Access Compliance Report

Public Rights-of-Way

(Curb Ramps)

Intersection ID: 48583	Main Street: STONEY_CREEK_LN	Cross Street: WATERLILY_LN	Location: SE
ADA ID: 3394394A00C3	Ramp Type: PerpDiag	Initial Pass/Fail: Pass	Overall Compliance: No
Severity Score: 20			
Codes/Mitigation Info/Possible Solution		Field Measurements/Component Compliance

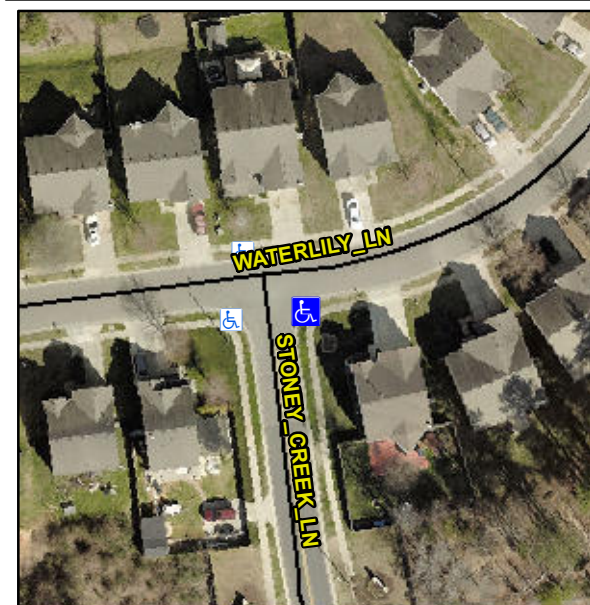
Not Found, R304.2.1, R302.7.2, R304.5.4

Compliance	Description	Data	Compliance	Description	Data
N/A	Ramp Length (in)	48.0	Yes	Ramp Slope (%)	6.7
Yes	Ramp Width (in)	49.0	Yes	Ramp XSlope (%)	0.1
N/A	Flare Type LT	Sloped	N/A	Flare Type RT	N/A
N/A	Flare Slope LT (%)	6.4	N/A	Flare Slope RT (%)	4.4
N/A	Flare Traversable LT?	No	N/A	Flare Traversable RT?	No
No	Landing Length (in)	47.0	Yes	DWS Provided?	Yes
Yes	Landing Width (in)	49.0	Yes	DWS Contrast?	Yes
Yes	Landing Slope (%)	1.6	Yes	DWS Length (in)	24.0
Yes	Landing X Slope (%)	0.5	Yes	DWS Full Width?	Yes
N/A	Landing Curb? (Y/N)	No	Yes	DWS Offset (in)	2.0
N/A	Shared Landing?	No			
Yes	Gutter Ponding?	No	No	Gutter Slope (%)	6.3
No	Gutter Lip Ht (in)	1.0	Yes	Gutter X Slope (%)	1.0
N/A	Painted X Walk1?	No	N/A	Painted X Walk2?	No
	X Walk 1 Direction	To N		X Walk 2 Direction	To W
N/A	X Walk 1 Width (in)	N/A	N/A	X Walk 2 Width (in)	N/A
	X Walk 1 Slope (%)	1.0		X Walk 2 Slope (%)	1.0
	X Walk 1 X Slope (%)	0.0		X Walk 2 X Slope (%)	2.1

N/A	Ramp inside XWalk1?	N/A	N/A	Ramp inside XWalk2?	N/A
	Road Slope (%)	1.2	N/A	Clear Space?	Yes
	Road X Slope (%)	0.6	N/A	Clear Space to XWalk (in)	N/A
Yes	Any Obstructions?	No	Yes	Storm Grate/Utility Hazard?	No
	Obstruction Type			Storm Grate/Utility Type	
		N/A			N/A
		Yes	Yes	Surface Condition? (G/P)	Good

Remove & Replace Curb Ramp With Two New Directional Ramps or Equivalent. Remove & Replace Gutter.
